SUBJECT: COMANCHE PEAK STEAM ELECTRIC STATION (CPSES)  
DOCKET NOS. 50-445 AND 50-446  
REQUEST FOR NRC REVIEW AND APPROVAL OF  
CHANGES TO CPSES EMERGENCY PLAN

DESCRIPTION AND JUSTIFICATION OF PROPOSED CHANGES TO THE CPSES EMERGENCY PLAN

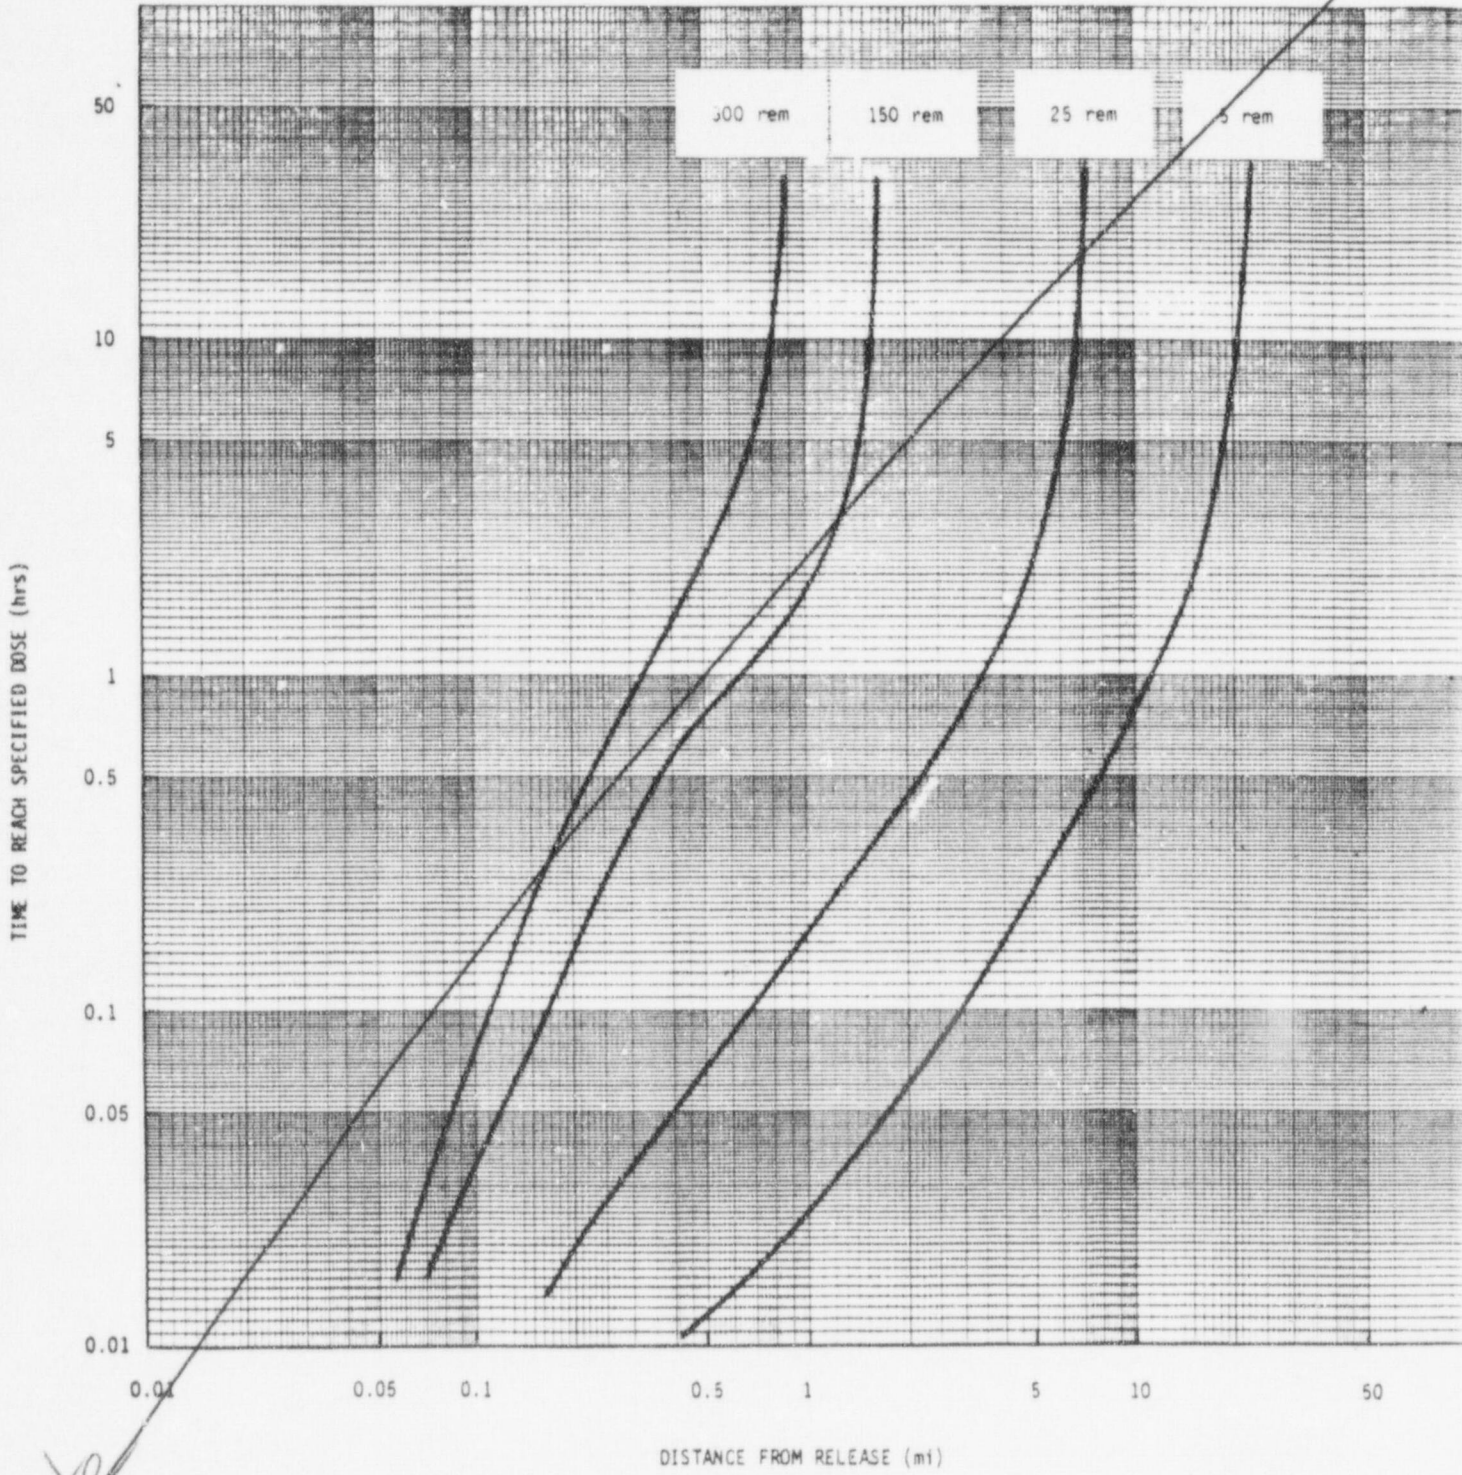
Delete Appendix B,C and D from the CPSES Emergency Plan.

This change deletes pre-1980 required graphs that compare reference thyroid or whole body dose values (including old 10 CFR Part 20 organ dose limits) to the doses that were estimated to be received by individuals at certain times and distances downwind of CPSES following a design basis accident (LOCA) and a radioactive release. These graphs were to provide a means for quickly assessing potential offsite dose consequences and aiding offsite protective action decision making. The graphs were originally developed per the guidance of Revision 0 (11/75) and Revision 1 (3/77) of Regulatory Guide (RG) 1.101 "Emergency Planning and Preparedness for Nuclear Reactors" which specified that graphs of post-LOCA time/distance/dose be prepared and provided in the emergency plan contents (Appendix) as described by RG 1.70, "Standard Format and Content of Safety Analysis Reports for Nuclear Power Plants".

<b>COMANCHE PEAK STEAM ELECTRIC STATION EMERGENCY PLAN</b>
THYROID DOSE FOLLOWING LOCA
FIGURE B.1

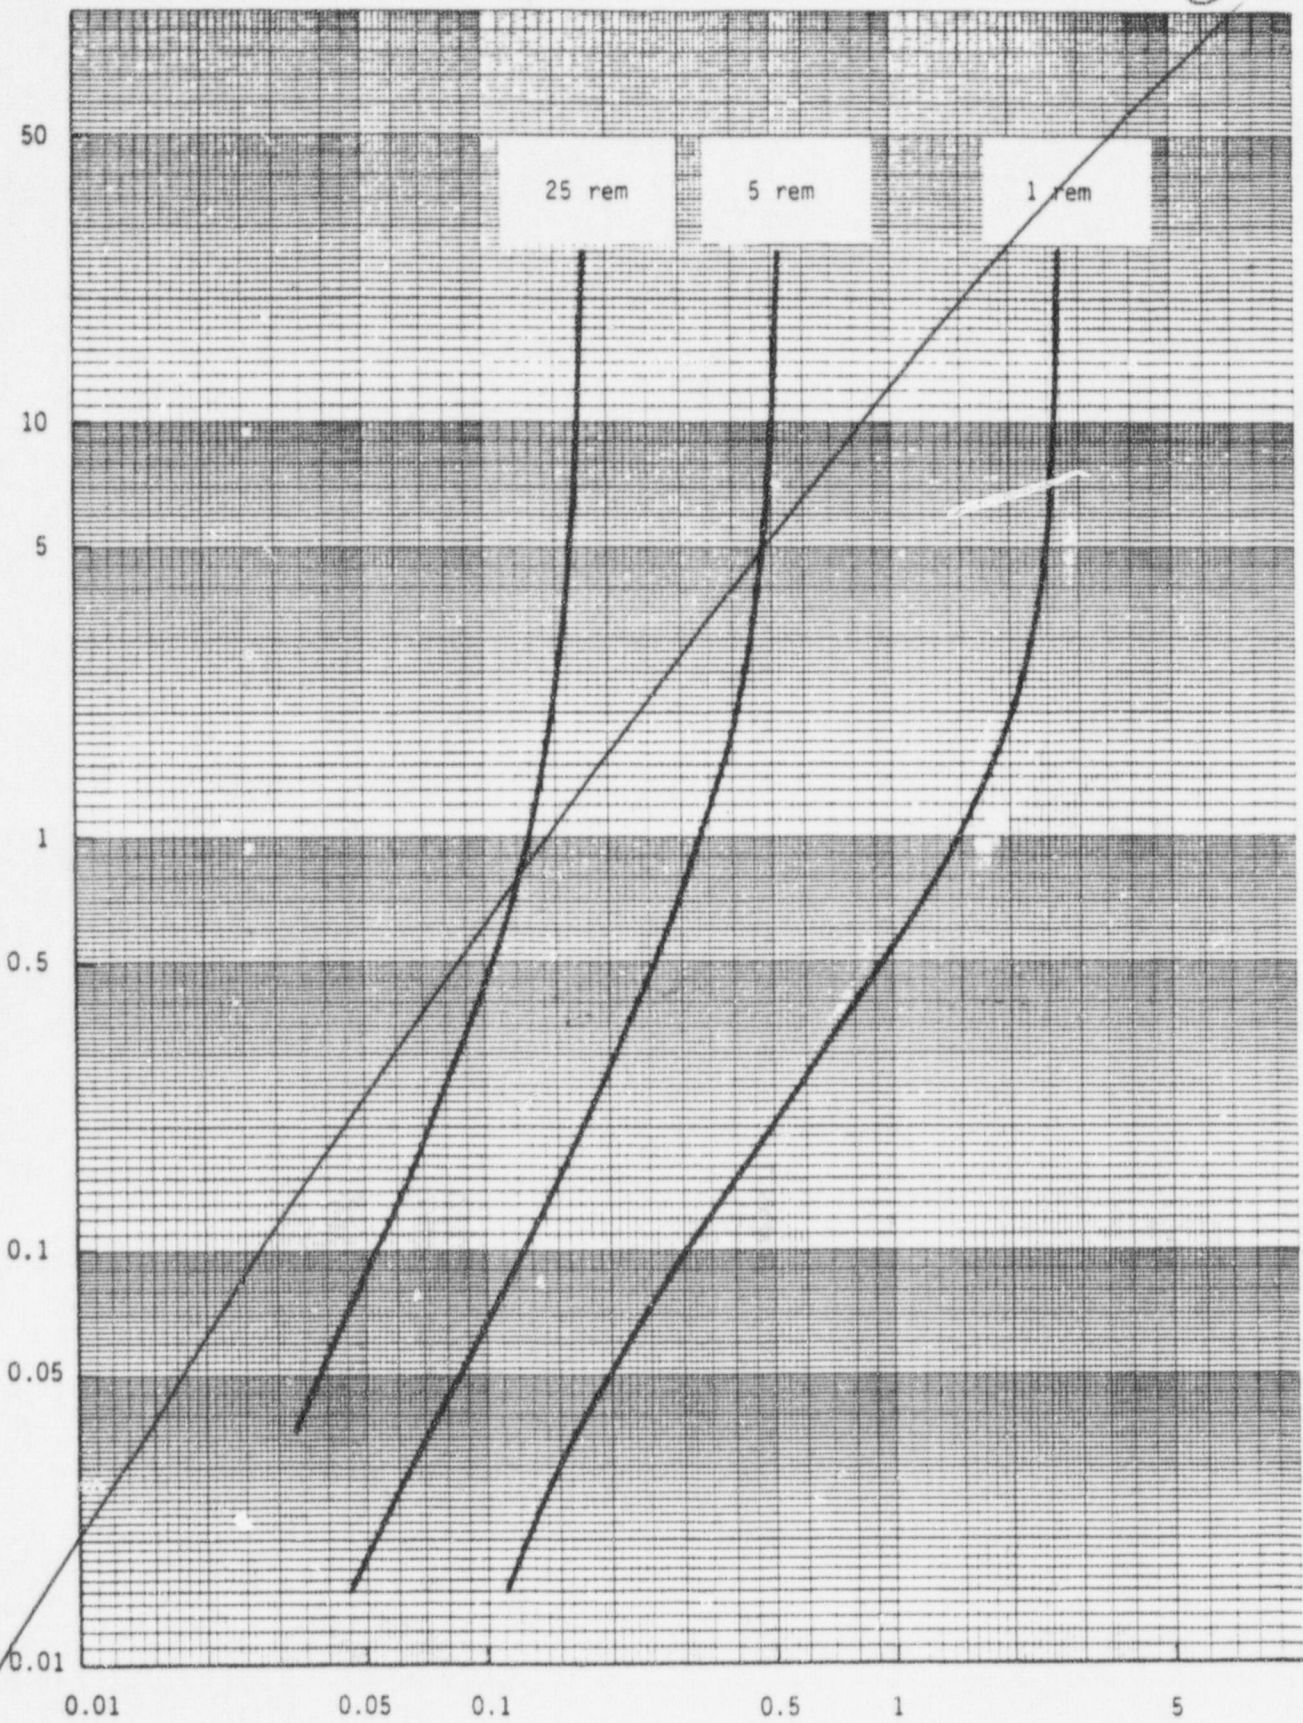
In August, 1980, the NRC upgraded its requirements for emergency preparedness in amendments to 10 CFR 50 (45 FR 55402). The NRC withdrew the guidance of RG 1.101 (Revision 1) in September, 1980, because it did not reflect the new requirements. In Revision 2 of RG 1.101, the NRC published new guidance (October, 1981) which endorsed the provisions of NUREG-0654 (FEMA-REP-1) as the preferred method to demonstrate compliance with the planning standards of 10 CFR 50.47. NUREG-0654 does not suggest development or inclusion of these graphs as part of an acceptable emergency plan. Subsequent developmental revisions of the CPSES Emergency Plan have failed to remove these obsolete graphs from the Appendices.

In the current CPSES Emergency Plan, which has been developed to the guidance of RG 1.101 Revisions 2 & 3 and has substantially incorporated the provisions of NUREG-0654, the graphical information in Appendices B, C and D is not used or referenced. These appendices are not currently used as a planning basis for offsite evacuations as was originally intended by RG 1.70, nor are they used as a tool during emergency response at CPSES. The current CPSES Emergency Plan, via NUREG-0654 guidance and provisions incorporated within Sections 7.0 "Accident Assessment" and 8.0 "Protective Response", encompasses the intent of these graphs. Finally, there is no mention of these appendices in the CPSES Safety Evaluation Report (SER) or supplements, related NRC inspection reports or correspondence.

Based on the above, it was determined that the subject graphs were not used as a licensing basis for the CPSES Emergency Plan and that deletion of the graphs should be acceptable.
